YOUDE 858DV4 PCB SCHEMATIC

PART IDENTIFIERS DO NOT MATCH THE BOARD SILKSCREEN

SUPPLY & FAN CONTROL

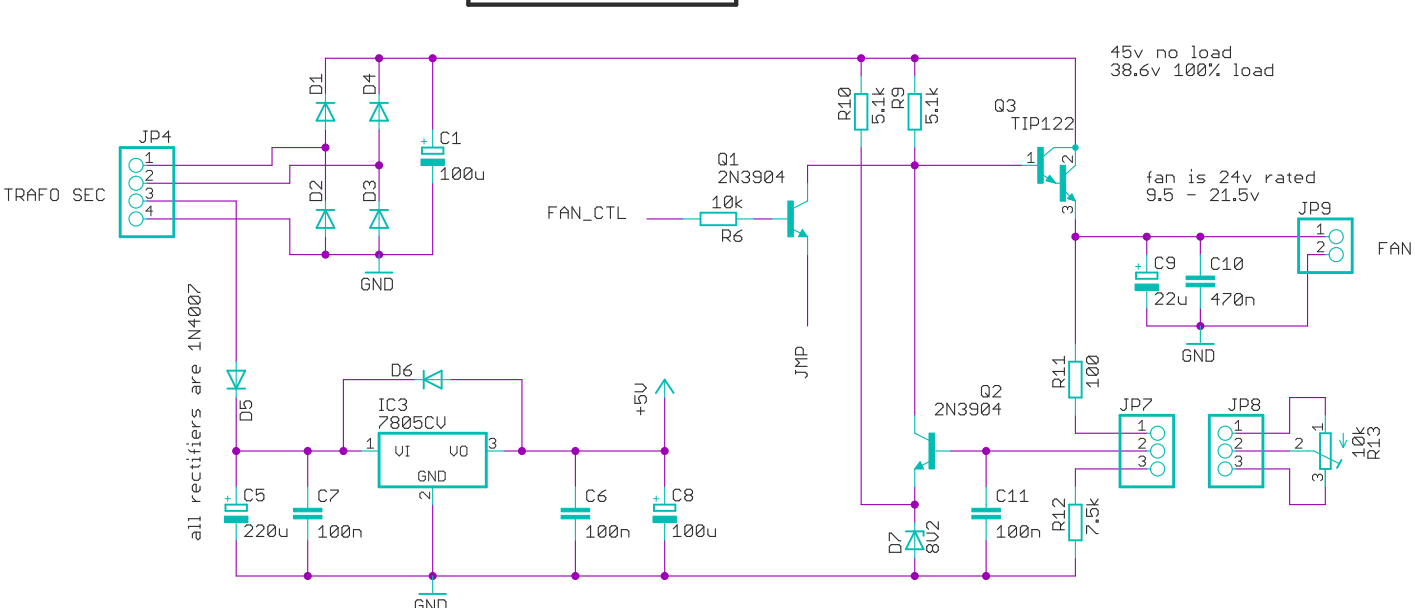
Q1 emitter is grounded through the internal connection of the UP pushbutton  
Q3 dissipation is about 2.45W at mid-scale

LINE VOLTAGE SECTION

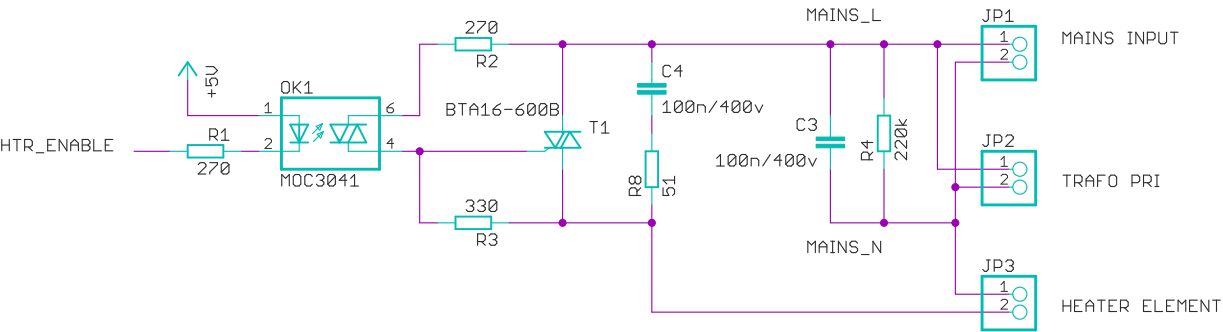
input polarity labels do not reflect actual chassis wiring as received
